July 15, 2008

Re: **Public Comment**
Recirculated Draft EIR – Berth 97-109 Container Terminal Project, April 2008

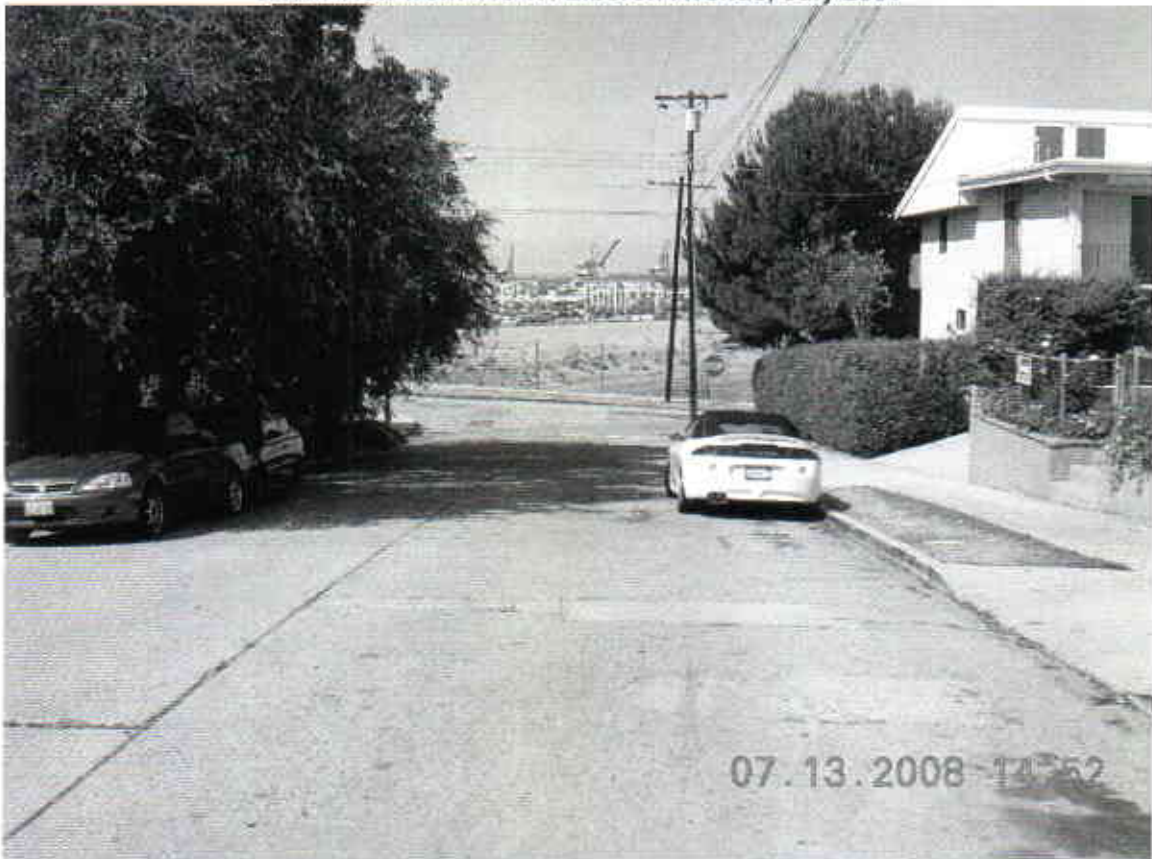
1. The EIR is deficient in identifying the aesthetic impacts of this project in that it only describes the visual impact of additional cranes at the terminal. However, the entire project is dependent upon the 45 acre fill in Southwest Slip constructed in 2001-2003 (concurrent with this project) as part of the Channel Deepening Project. The aesthetic impacts of that fill are excluded from this EIR. Since this China Shipping project includes developing this same fill site for terminal backlands establishing a “footprint”, and it commenced within the same timeframe (2002), I am including its associated environmental impacts in this comment document. To consider the Southwest Slip fill as a separate project would constitute “piece-mealing” or project linkage.
